MODIFICATION PROPOSAL FORM**WFPS FAULT RIDE-THROUGH***FORM GC1, PROPOSAL OF MODIFICATION TO GRID CODE.*

MODIFICATION PROPOSAL ORIGINATOR:	EirGrid		
MODIFICATION PROPOSAL ORIGINATOR (CONTACT NAME)	David Cashman	MODIFICATION PROPOSAL ORIGINATOR FAX NUMBER:	
MODIFICATION PROPOSAL ORIGINATOR TELEPHONE NUMBER:	01-2370122	DATE:	04/09/2012
MODIFICATION PROPOSAL ORIGINATOR E-MAIL ADDRESS:	david.cashman@eirgrid.com	MODIFICATION PROPOSAL NUMBER (EIRGRID USE ONLY)	MIPD 230
GRID CODE SECTION(S) AFFECTED BY PROPOSAL:	WFPS1.4.1, WFPS1.4.2		
GRID CODE VERSION :	4.0		
MODIFICATION PROPOSAL DESCRIPTION (MUST CLEARLY STATE THE DESIRED AMENDMENT, ALL TEXT/FORMULA CHANGES TO THE GRID CODE. THE REQUIRED REASON FOR THE MODIFICATION MUST STATED. ATTACH ANY FURTHER INFORMATION IF NECESSARY.)	<p>To amend WFPS1.4 to specify new fault ride through specifications for WFPS connected to the transmission system. Active and Reactive Power responses for the WFPS are to be re-defined to offer a more rapid response from WFPS during and after a system event.</p> <p>Amended Text and Diagrams are shown below.</p>

Figure WFPS1.1 – Fault Ride-Through Capability of Controllable WFPSs

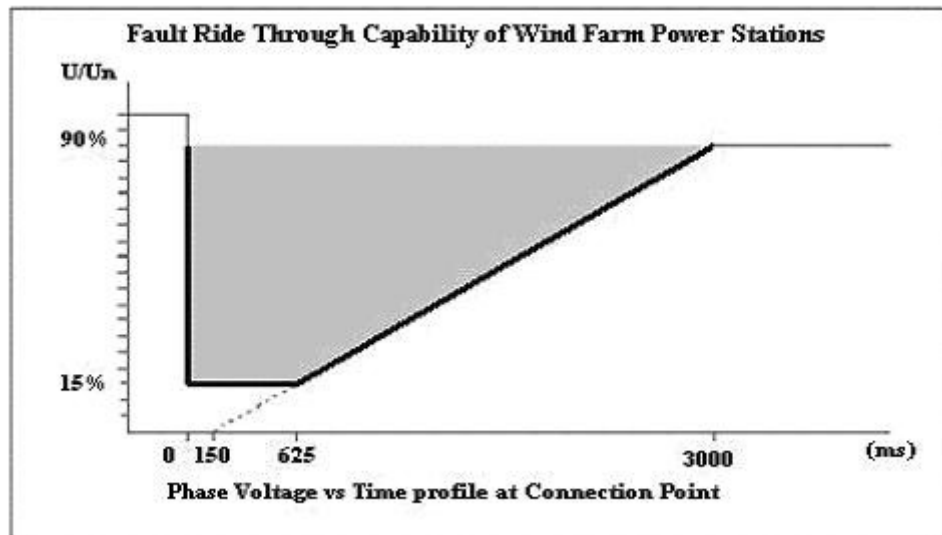
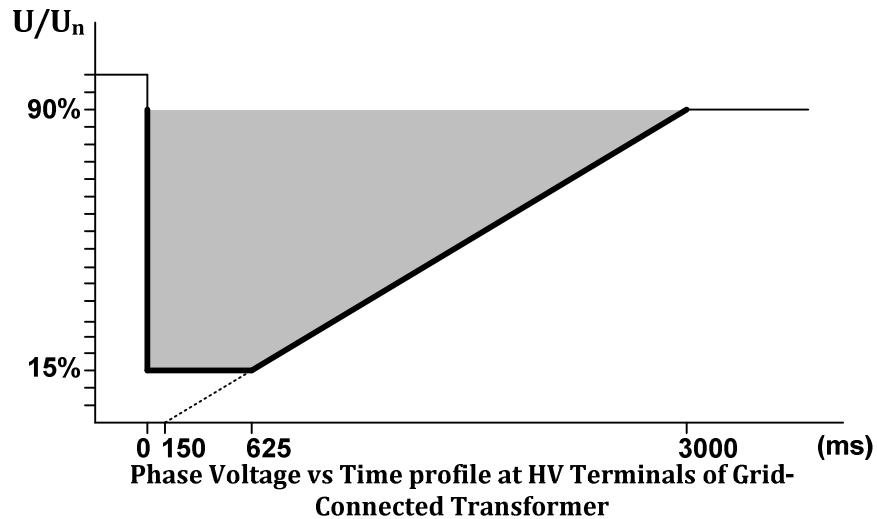
WFPS1.4.1 A Controllable WFPS shall remain connected to the Transmission System for Transmission System Voltage Dips on any or all phases, and shall remain stable, where the Transmission System Phase Voltage measured at the HV terminals of the Grid Connected Transformer remains above the heavy black line in *Figure WFPS1.1*.
